**PLN20/0006 - 462 - 482 Swan Street, Richmond - Construction of a thirteen storey building (including one level of plant, plus two basement levels), reduction in the car parking requirement associated with the retail/food and drinks premises and office uses (no permit required for uses) and alteration of access to a Road Zone, Category 1**

## **Executive Summary**

**CONTACT OFFICER:** Michelle King  
**TITLE:** Principal Planner  
**TEL:** 9205 5333

Figure 16: Extracts from the landscape concept plan, highlighting the indented setback between podium forms, where 'vertical gardens' are proposed on the northern, western and southern facades

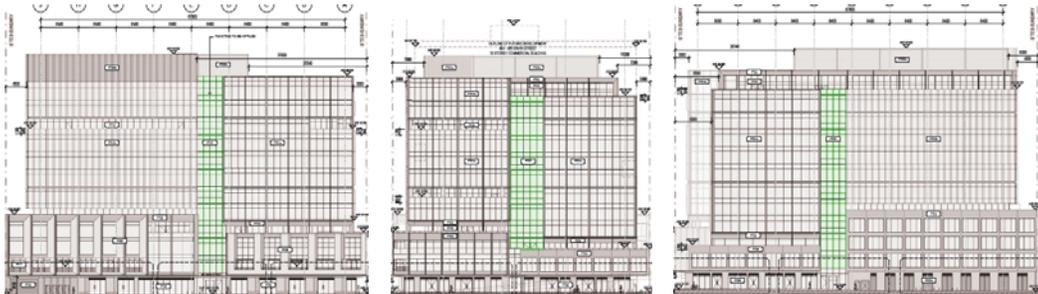
- 202. Where the podium forms step up or down, the building provides an indented setback to assist in breaking down the massing of the long site frontage and the differing podium forms. This is particularly evident above the podium and is highlighted within the landscape concept plan (Figure 16).

Figure 20: Section B-B and Section C-C showing the 6 metre high parapet proposed to conceal roof plant along the Swan Street interface

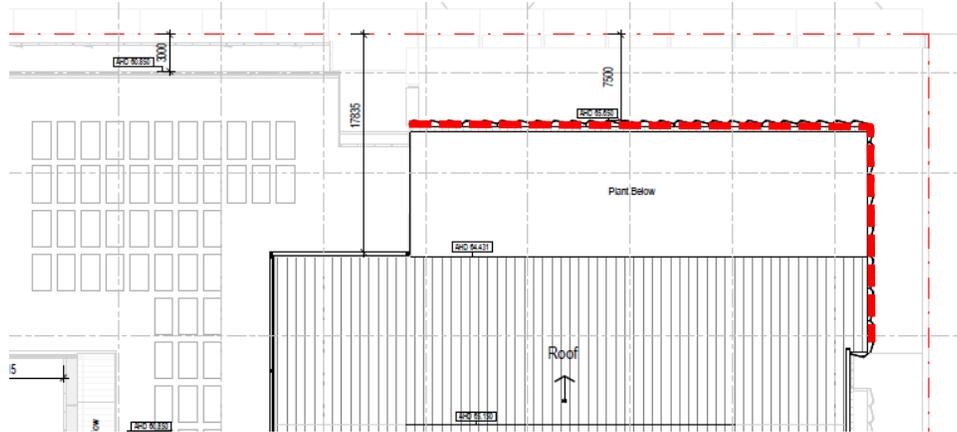
225. Whilst the overall building height does not include plant, DDO14 requires building services to be hidden from view or designed as architectural roof top features. In this instance, the parapet of the building as identified in Figure 19 has been extended by 6 metres in height to conceal the plant, as shown in Figure 20.

227. In addition to this, it is considered that the proposed height of the roof top plant and parapet is unnecessary, resulting in excessive and avoidable visual bulk. The 6 metre high parapet as identified within Figure 19 is to be clad in 'FT03a', a grey powder coated coloured aluminium perforated façade system. This material placed above the lightweight 'FT01b', the glazed curtain wall system Type 2 – articulated façade system, will be visually prominent and there is concern it would accentuate the building height resulting in a 'top heavy' design.

Figure 21: Extract from the urban context report, showing smaller retail tenancies

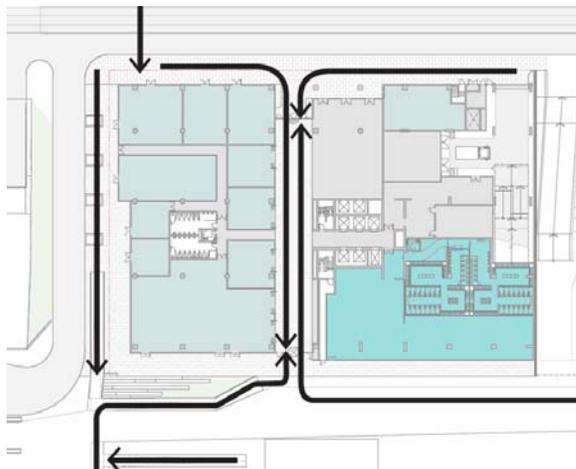
304. Other documentation indicates that this space will be utilised as a market and it is understood from the applicant that the detailed design is in the early stages as a result of discussions with potential retail tenants. As Figure 21 demonstrates, the Urban Context Report envisions the larger retail tenancies to be broken up into smaller spaces.

305. To ensure that the development adequately reflect the finalised ground floor plan in respect of the retail tenancies, and to ensure that the finalised retail scheme is consistent with the documentation submitted, a condition can require the detailed design of the retail spaces to be shown with their uses identified. A condition can also require the WMP be updated to reflect the proposed uses, if required.
306. A 40sqm 'soft slab' is proposed along the western interface of Levels 3 to 7. The inclusion of this 'soft slab' will enable future tenancies that occupy several floors to provide internal stairs to connect the office floor areas and is considered an appropriate future proofing measure to ensure efficient use of the building once it is tenanted.
